ADDENDUM NO. 2

TO: PLANS AND SPECIFICATIONS FOR STATE OF MISSOURI

**Replace Roofs & Renovate Exterior, Multiple Assets
Missouri State Fairgrounds
Sedalia, Missouri
PROJECT NO. F1906-01**

DRAWING NO.
AD2.0
REVISED CAULFIELD
BLDG. / LIGHT HORSE
ROOF PLAN

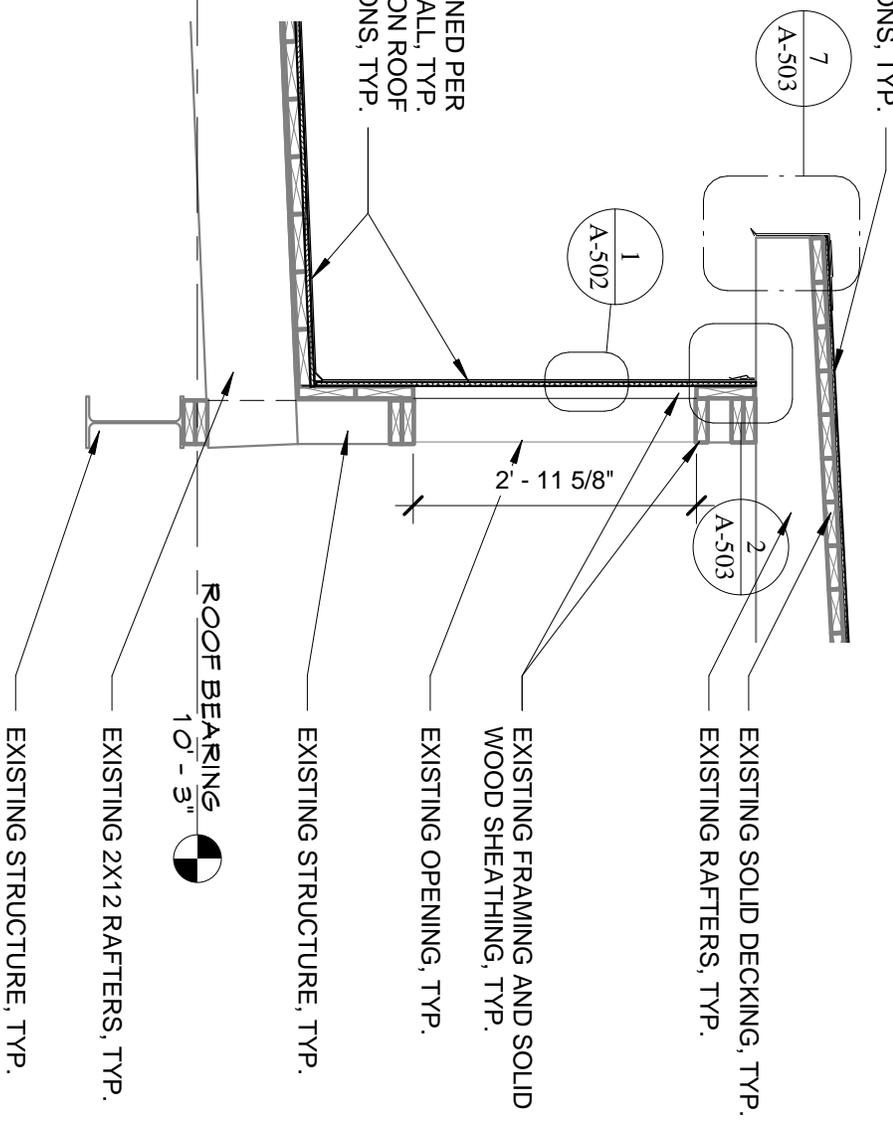
- 4. Sheet A-123
 - a. See attached drawing AD2.0 / REVISED CAULFIELD BLDG. / LIGHT HORSE ROOF PLAN for changes to the cricket slopes.
- 5. Sheet A-201
 - a. 1/A-201 – East Elevation, See attached drawing AD2.12 / ADDITION OF WINDOW E, for the addition of two windows, changed from sheathing and break metal.

ALTERNATE CAULFIELD
BLDG. / LIGHT HORSE
CLERESOTRY DETAIL

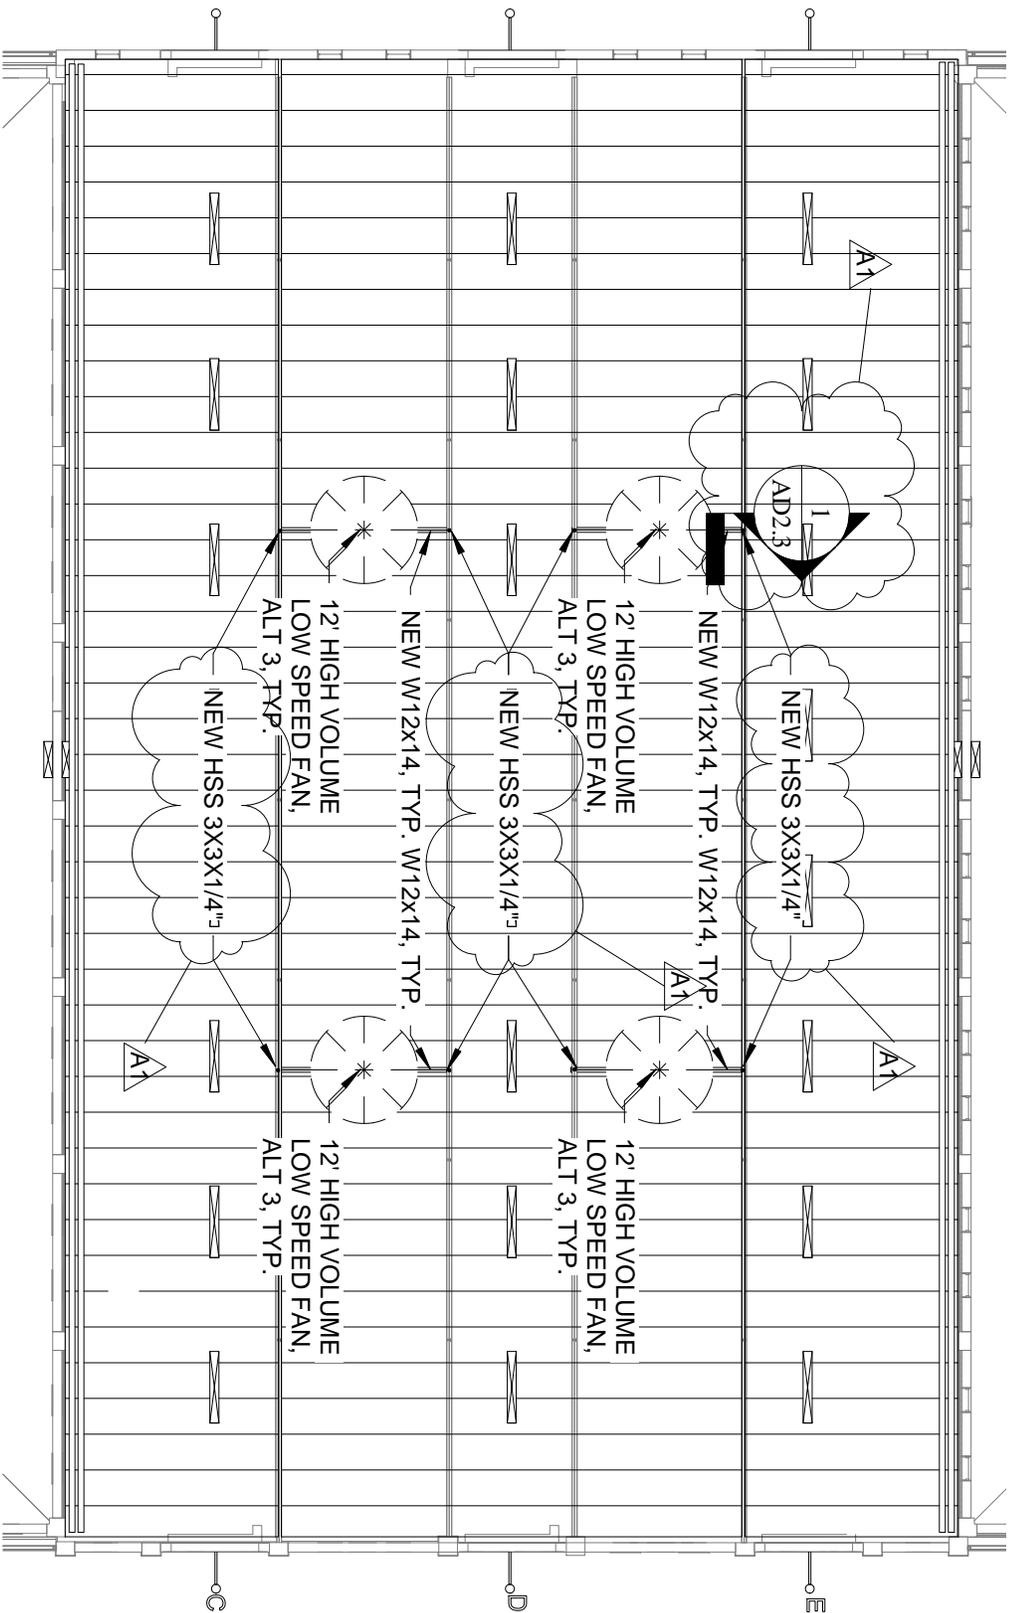
- 7. Sheet A-402
 - a. See attached drawing AD2.1 / ALTERNATE CAULFIELD BLDG. / LIGHT HORSE CLERESTORY DETAIL for an alternate detail to 2/A-402 – CLERESTORY WALL DETAIL. It shall be the GC's option to demolish the standing seam metal siding from clerestory wall and replace with sheathing and TPO per attached drawing AD2.1 / ALTERNATE CAULFIELD BLDG. / LIGHT HORSE CLERESTORY DETAIL, in lieu of 2/A-402 – CLERESTORY WALL DETAIL in the construction drawings. The standing seam metal siding shall remain on the brick walls.

STRUCTURAL
REINFORCING AT
CAULFIELD BLDG. / LIGHT
HORSE

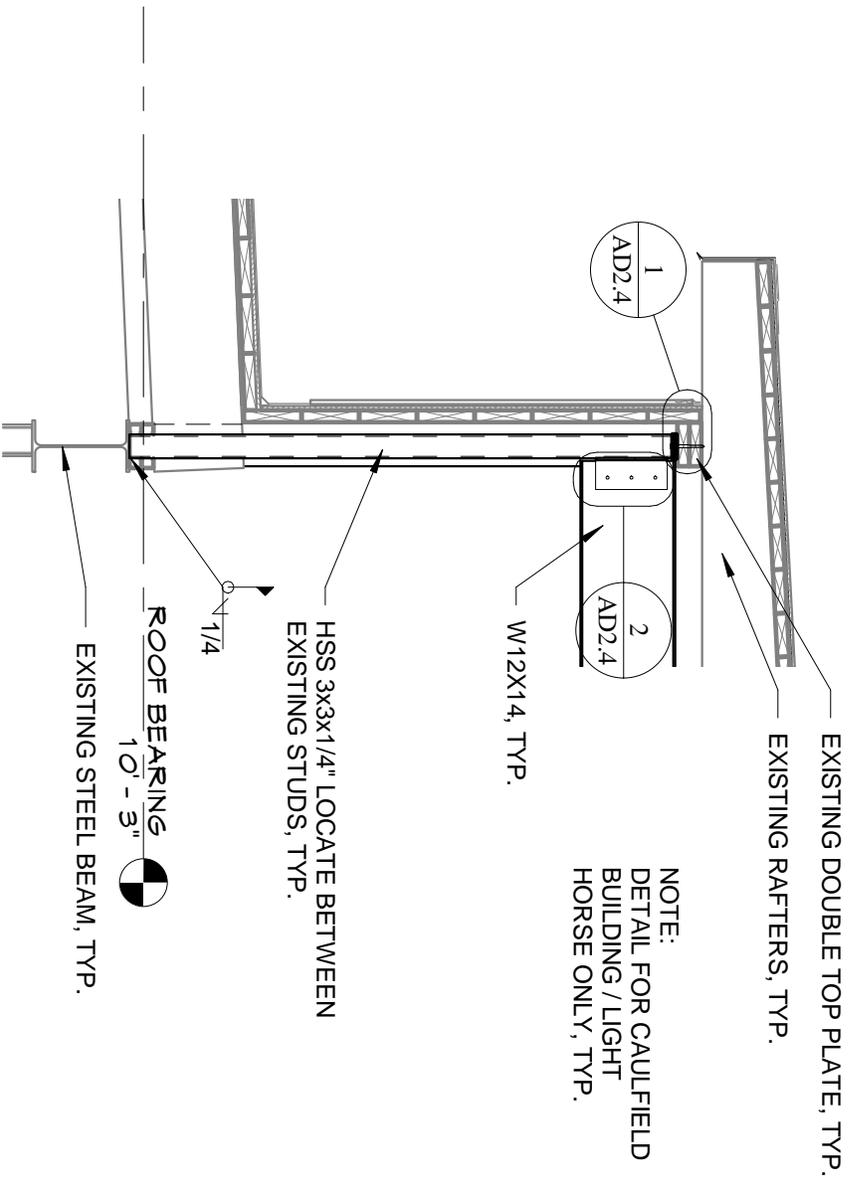
1. Sheet D-121
 - a. Revise demolition note 3 as follows:
 - i. Demo existing standing seam metal roof, metal roof risers, and coal tar and gravel roof down to existing deck, typ.
2. Sheet S-101
 - a. See attached drawings AD2.2 / STRUCTURAL REINFORCING DETAIL CAULFIELD BLDG, AD2.3 / STRUCTURAL REINFORCING DETAIL CAULFIELD BLDG, / LIGHT HORSE and AD2.4 / STRUCTURAL REINFORCING DETAILS CAULFIELD BLDG, / LIGHT HORSE for structural details in relation to the addition of structural reinforcing for the high volume low speed fans in the Caulfield Bldg. / Light Horse. Structural additions shall be in the base bid. Structural additions for the Heavy Horse and Light Horse buildings are not changed.

FIBER-OPTIC CABLE
RE-FEED
AT LIGHT HORSE
BUILDING

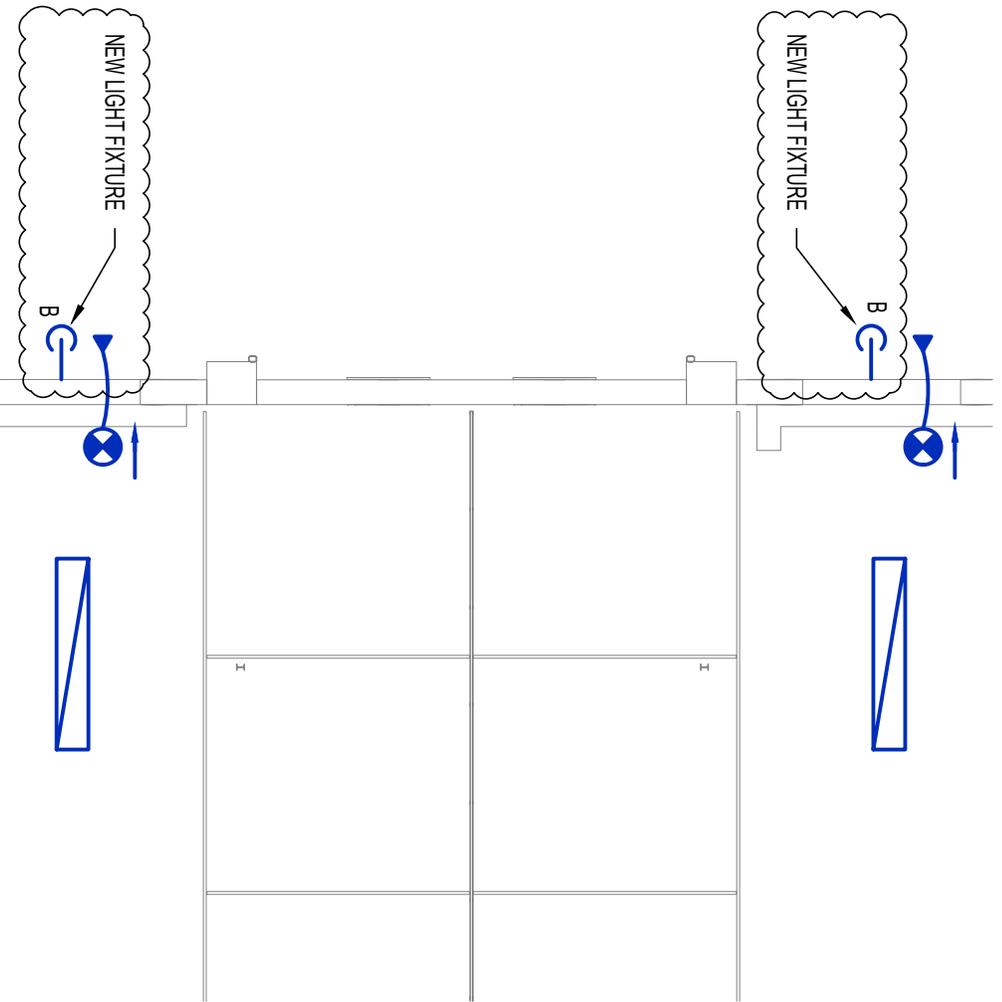
- b. As a clarification, GC shall install (4) total bollards. (2) each at each roof drain outflow as indicated on the drawings.
- 9. Sheet EP-102
 - a. See attached drawing AD2.5 for the following changes:

- i. Added keyed note 10 – reference to existing fiber box to remain.
 - ii. Added keyed note 11 – reference to re-feed of fiber prior to louver replacement.

- 1 EXISTING WALL MOUNTED FIBER-OPTIC TERMINATION ENCLOSURE TO REMAIN.
- 2 EXISTING FIBER-OPTIC CABLE ROUTED THROUGH LOUVER. PRIOR TO LOUVER REPLACEMENT, COORDINATE DISCONNECTION & RE-FEED THROUGH NEW CONDUIT & WEATHER-HEAD WITH FIBER PROVIDER.

NEW LIGHT FIXTURES
EXTERIOR WEST WALL,
HEAVY HORSE BUILDING

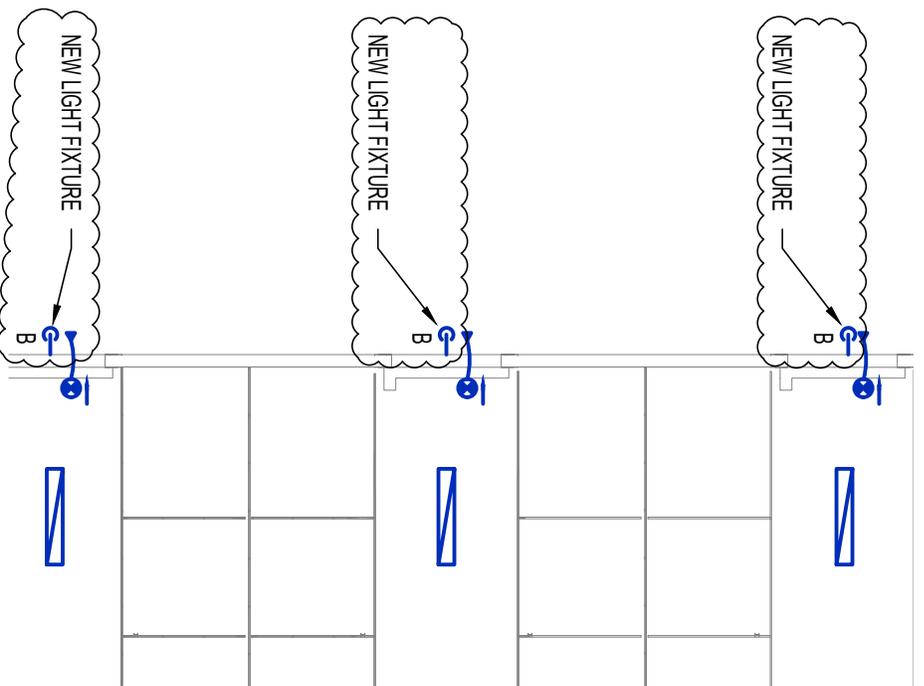
- 10. Sheet EL-100
 - a. See attached drawing AD2.6 for the following changes:

- i. Remove keyed note 1 from two exterior light fixtures 'B' on the West side. These will be entirely new fixtures, not new fixtures replacing existing as previously noted.

DRAWING NO. **AD2.8**
NEW LIGHT FIXTURES
EXTERIOR WEST WALL,
LIGHT HORSE BUILDING

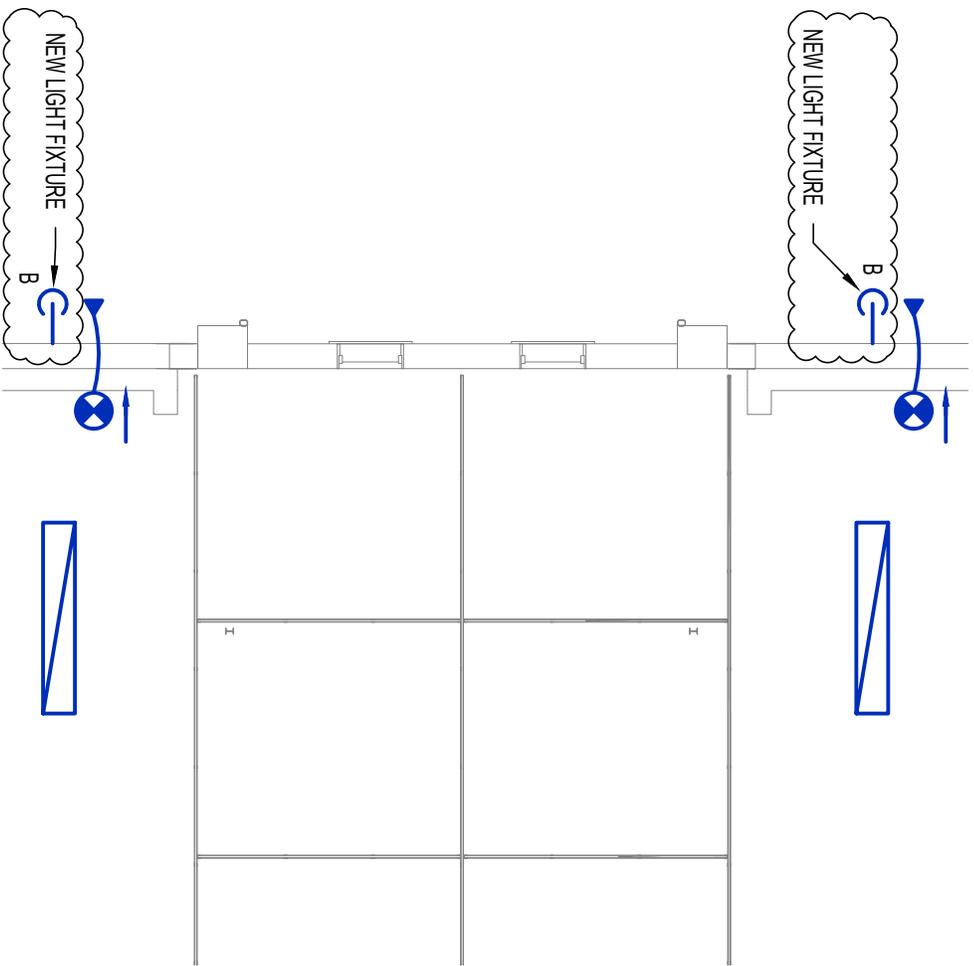
12. Sheet EL-102

- a. See attached drawing AD2.8 for the following changes:
 - i. Exterior light fixtures previously incorrectly tagged as 'C' fixtures. Drawing revised with correct 'B' fixture tag.
 - ii. Remove keyed note 1 from two exterior light fixtures 'B' (formerly 'C') on the West side. These will be entirely new fixtures, not new fixtures replacing existing as previously noted.
- b. See attached drawing AD2.9 for the following changes:
 - i. Exterior light fixtures previously incorrectly tagged as 'C' fixtures. Drawing revised with correct 'B' fixture tag.

DRAWING NO. **AD2.10**
POWER RISER #1

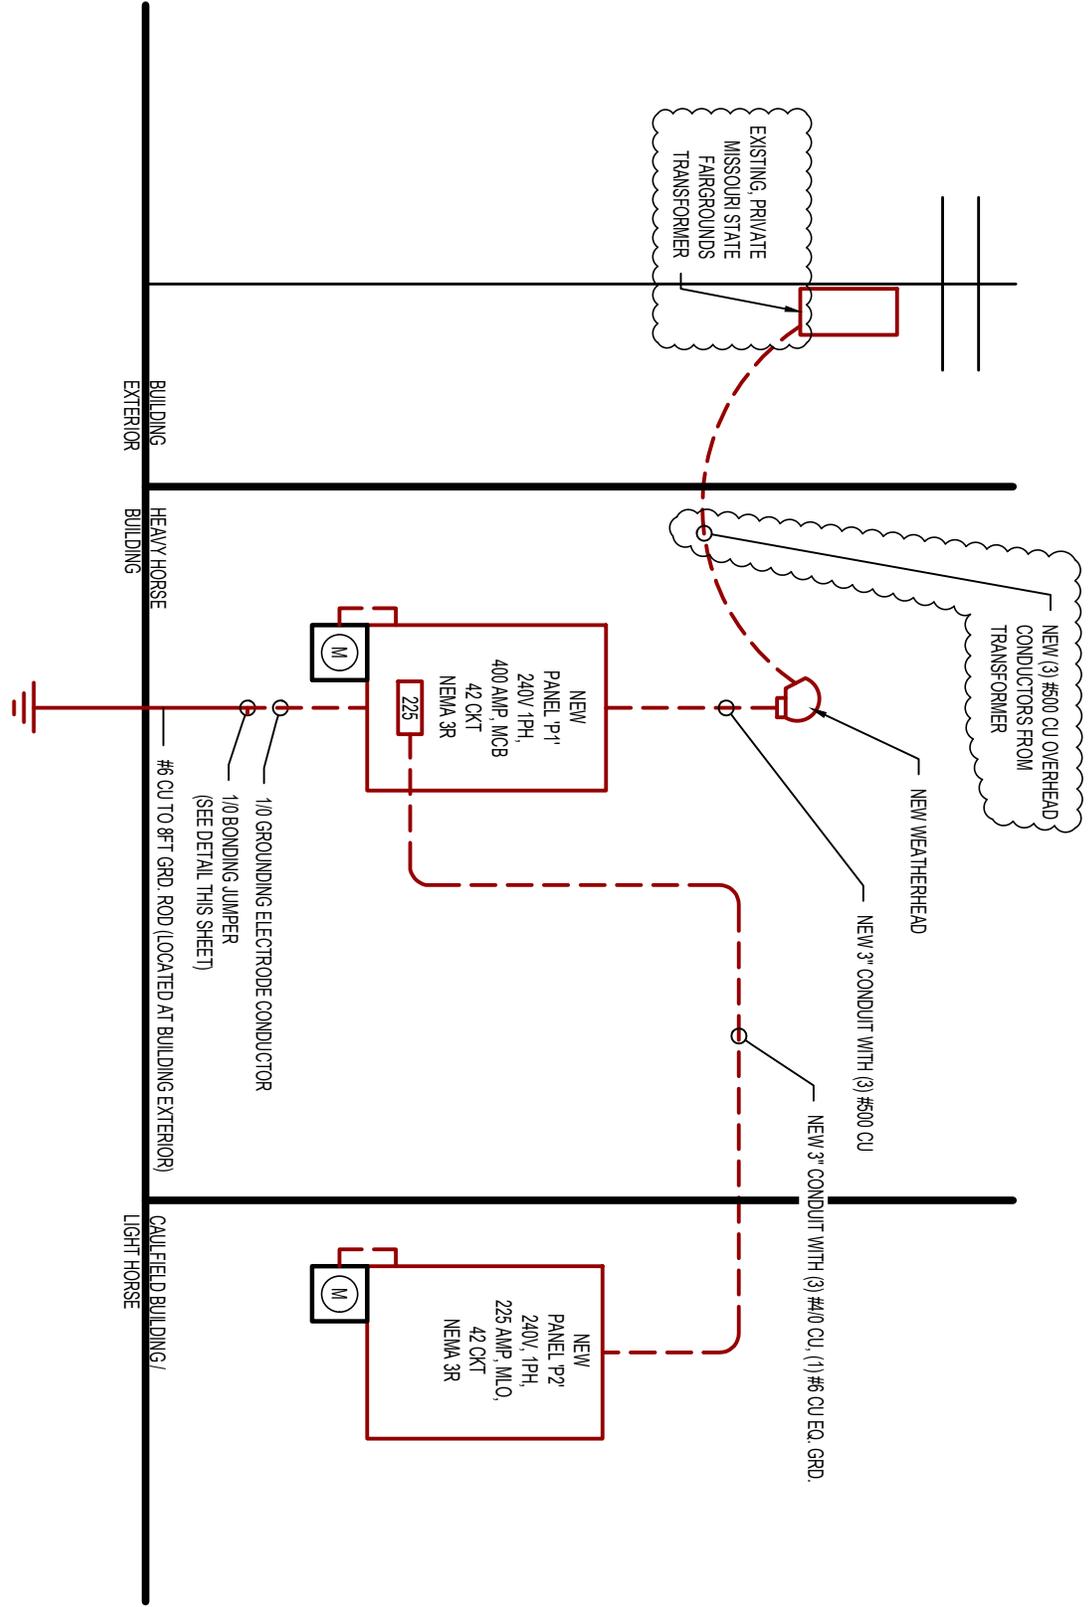
13. Sheet ED-100

- a. See attached drawing AD2.10 for the following changes:
 - i. Notes added to 'Power Riser #1' to clarify transformer ownership.
 - ii. Note added to 'Power Riser #1' to clarify new conductors to be installed from private transformer to new weatherhead/ new service conductors.
- b. See attached drawing AD2.11 for the following changes.
 - i. Note added to 'Power Riser #2' to clarify transformer ownership.
 - ii. Note added to 'Power Riser #2' to clarify existing overhead conductors to remain.
